ADDENDUM NO. 1

PROJECT: Fort Owen State Park – East Barracks Preservation

FWP PROJECT #: 22-08

Fort Owen East Barracks Preservation
Details - Alternate No. 1 & 2

SHEET: 7R
of 10

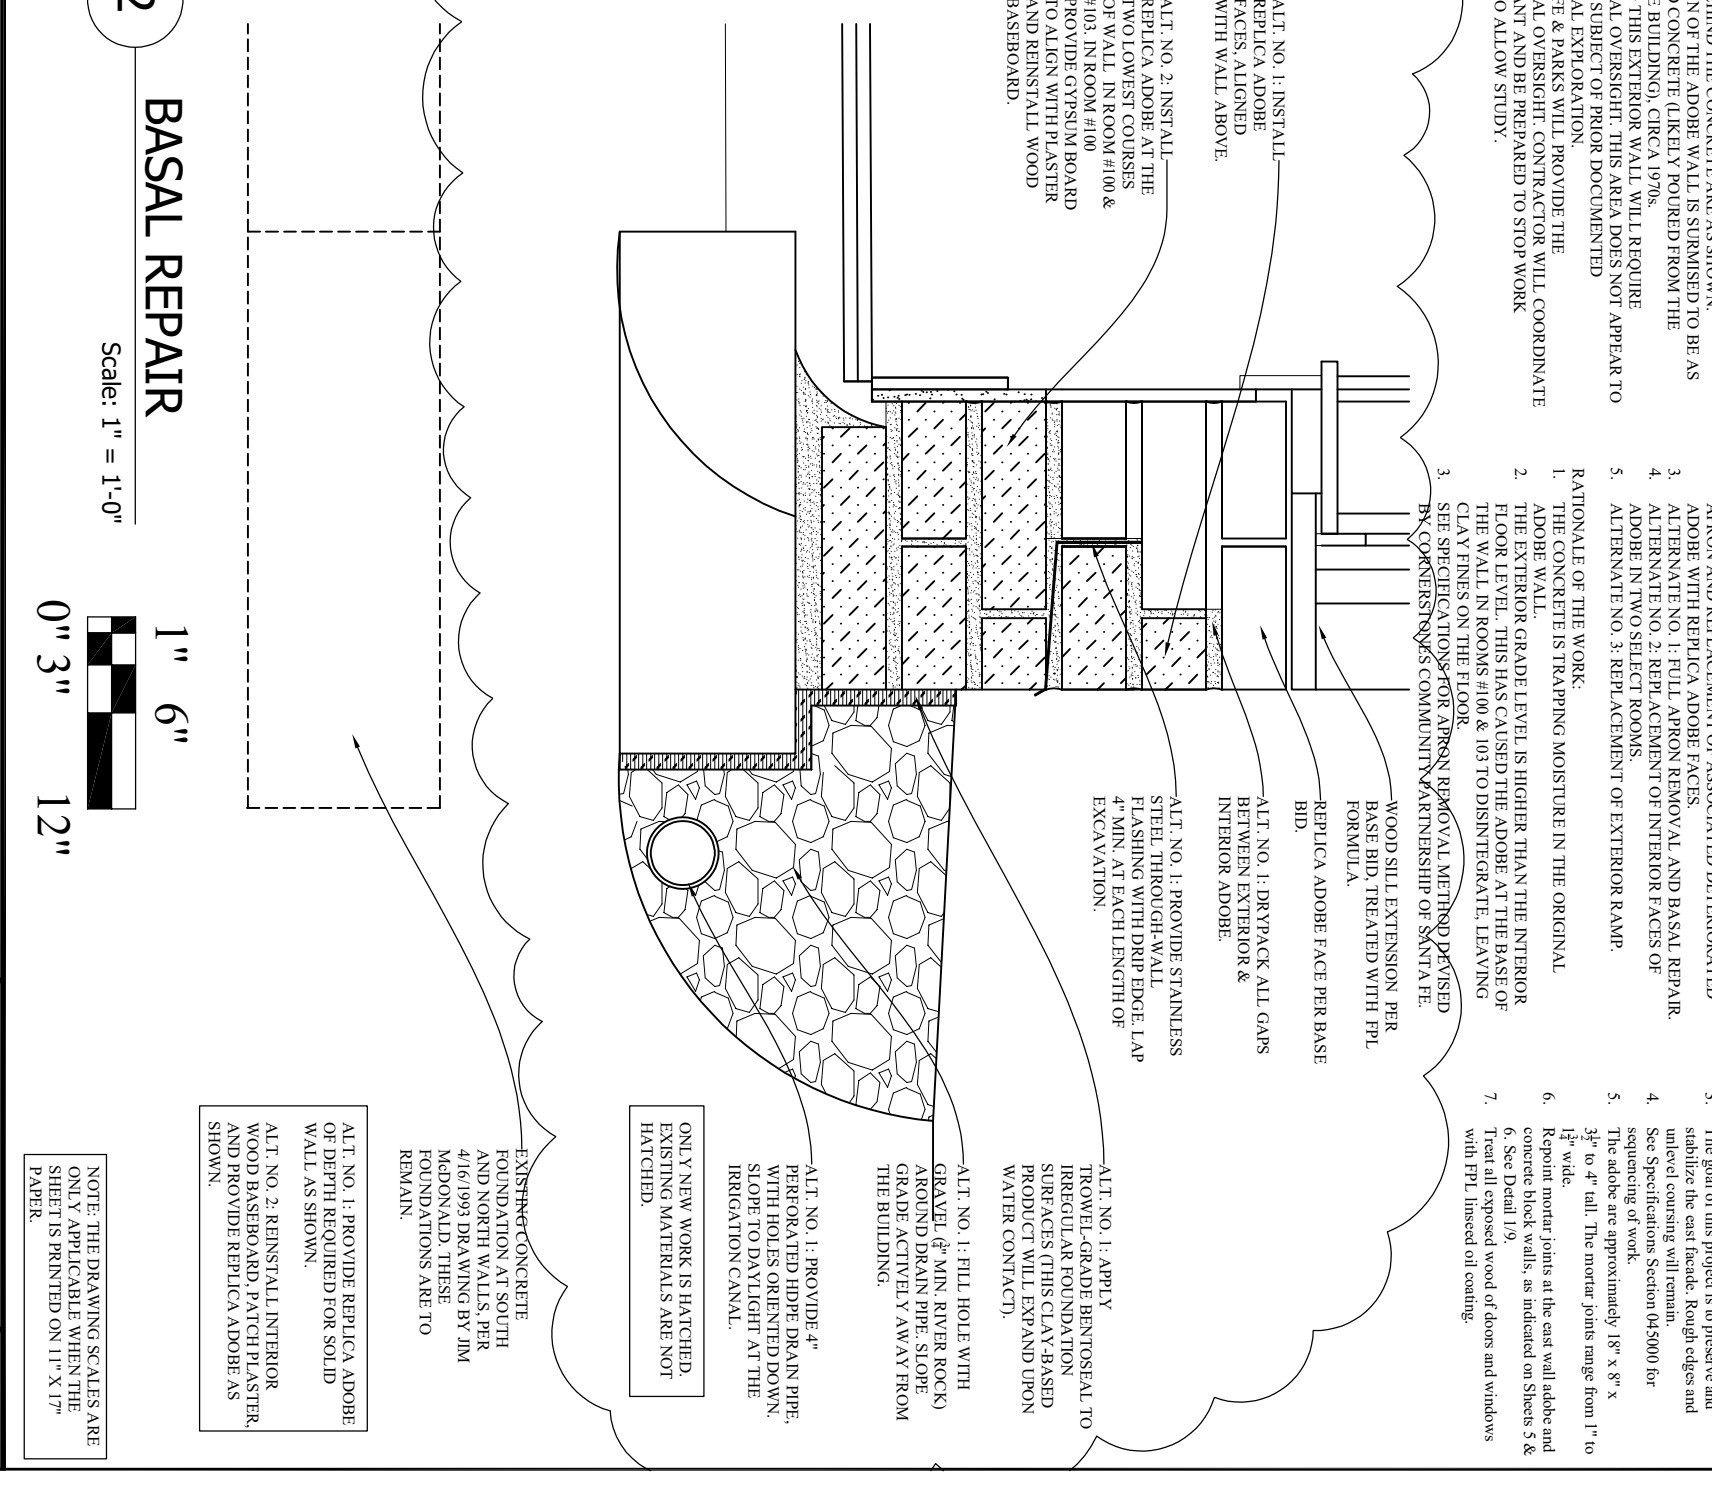
1. **Drawing Sheets:** Replace Sheet 7 with the attached revised Sheet 7R, dated 5/2/2022.
2. **Technical Specifications:** Replace the following items in Technical Specification Section 012200 – Unit Prices:
 - a. Replace all references to “Sheet 7” with “Sheet 7R.”
 - b. Replace Item F in its entirety with the following:
